**Agenda item:** Ad hoc 1  
**Source:** Bosch  
**Title:** Answers to Tdoc TSGR1#9(99)i06  
**Document for:** Discussion

Joint Predistortion (JP) was extensively discussed at RAN1 meeting #8. No decision could be reached. To come to a conclusion, companies were asked to summarise remaining concerns. [1] is such a list of concerns and comments on JP. Here we try to give answers to those comments.

Fig.1: Mips requirements (real multiplications) of JP and JD in the indoor and pedestrian A environment.

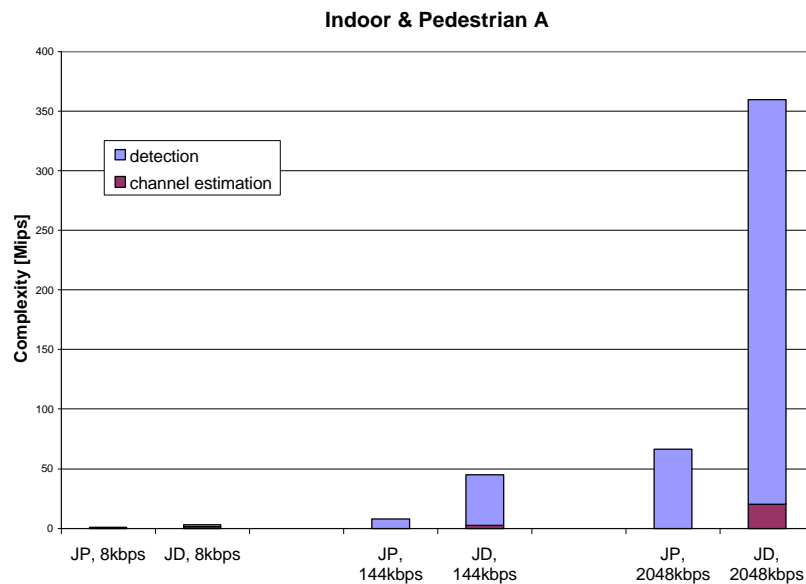
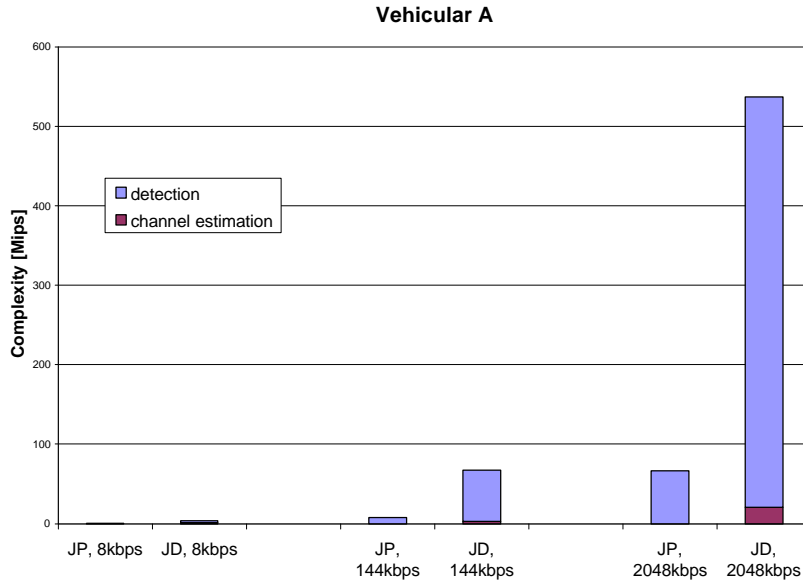
5.4. Additional complexity results for the case of multicode in DL should be provided, since all the former simulations assume variable spreading (SF=2) in DL.

The following figures compare JP and approximate JD detection complexities when using multiple codes. Since there are no approximate JD complexities available for the mappings of [2], we use multicode JD complexities taken from [6] for alternative mappings. JP detection complexities are calculated for the same mappings.

When using multiple codes, JP saves complexity by a factor of at least 5.4 at high data rates.
